Access Compliance Report

Public Rights-of-Way

Intersection ID: 48024	Main Street: LADLEY_CT	Cross Street: OLD_PROVIDENCE_RD	Location: S
ADA ID: B5447C754683	Ramp Type: PerpDiag	Initial Pass/Fail: Fail	Overall Compliance: No
		Severity Score: 22.5

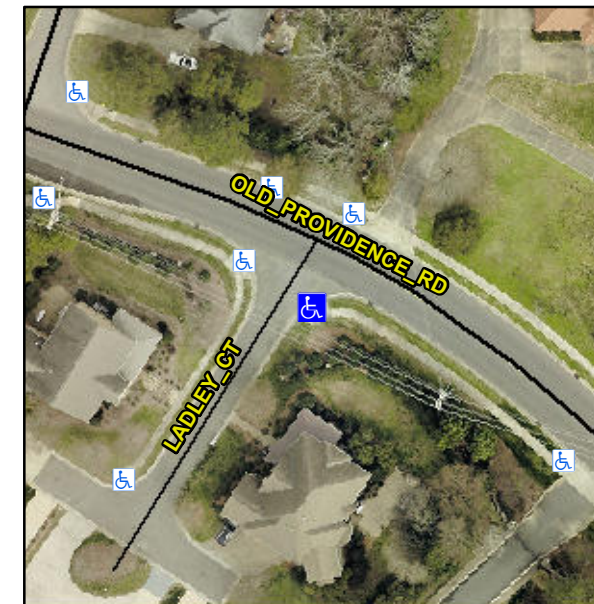
Not Found, R304.5.1, R304.2.2, R304.5.3

Compliance	Description	Data	Compliance	Description	Data
N/A	Ramp Length (in)	58.0	No	Ramp Slope (%)	9.7
No	Ramp Width (in)	47.0	No	Ramp XSlope (%)	2.9
N/A	Flare Type LT	N/A	N/A	Flare Type RT	N/A
N/A	Flare Slope LT (%)	N/A	N/A	Flare Slope RT (%)	N/A
N/A	Flare Traversable LT?	N/A	N/A	Flare Traversable RT?	N/A
N/A	Landing Length (in)	N/A	N/A	DWS Provided?	N/A
N/A	Landing Width (in)	N/A	N/A	DWS Contrast?	N/A
N/A	Landing Slope (%)	N/A	N/A	DWS Length (in)	N/A
N/A	Landing X Slope (%)	N/A	N/A	DWS Full Width?	N/A
N/A	Landing Curb? (Y/N)	N/A	N/A	DWS Offset (in)	N/A
N/A	Shared Landing?	N/A			
N/A	Gutter Ponding?	N/A	N/A	Gutter Slope (%)	N/A
N/A	Gutter Lip Ht (in)	N/A	N/A	Gutter X Slope (%)	N/A
N/A	Painted X Walk1?	No	N/A	Painted X Walk2?	No
	X Walk 1 Direction	To NE		X Walk 2 Direction	To NW
N/A	X Walk 1 Width (in)	N/A	N/A	X Walk 2 Width (in)	N/A
	X Walk 1 Slope (%)	4.3		X Walk 2 Slope (%)	2.1
	X Walk 1 X Slope (%)	2.0		X Walk 2 X Slope (%)	3.1

Remove & Replace Curb Ramp With Two New Directional Ramps or Equivalent.
